Product Change Notification

PCN#: 257

Change Title: HC49SDLF Series Dimensional Changes

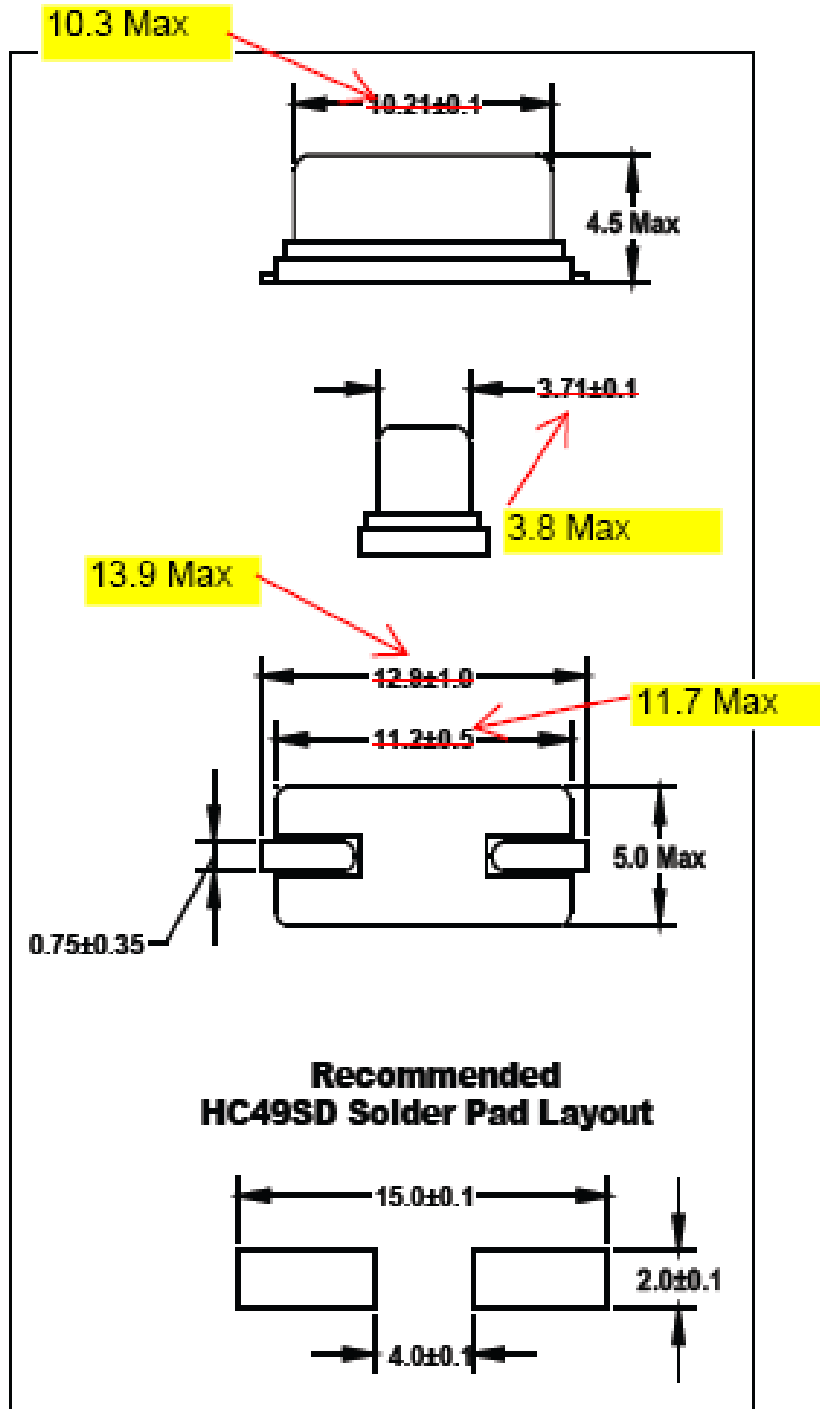
Description of Change to the Customer: In order correct some drawing errors and to bring our datasheet more in line with our production specifications, we are changing certain HC49SDLF dimensional specifications as outlined below.

Top of can length – from 10.21 ± 0.1 mm to 10.3mm Max
Top of can width – from 3.71 ± 0.1 mm to 3.8mm Max
Base insulator length – from 11.2 ± 0.5 mm to 11.7mm Max
Total length – from 12.9 ± 1.0 mm to 13.9mm Max

HC49SDLF Dimensional Changes 11/20/06

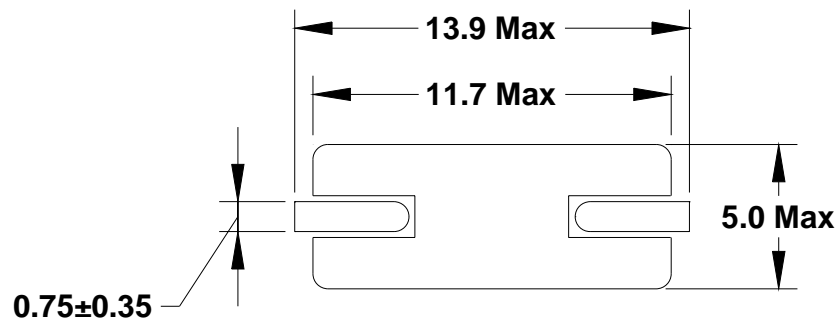
A markup showing the exact changes and a revised dimensional drawing are attached.
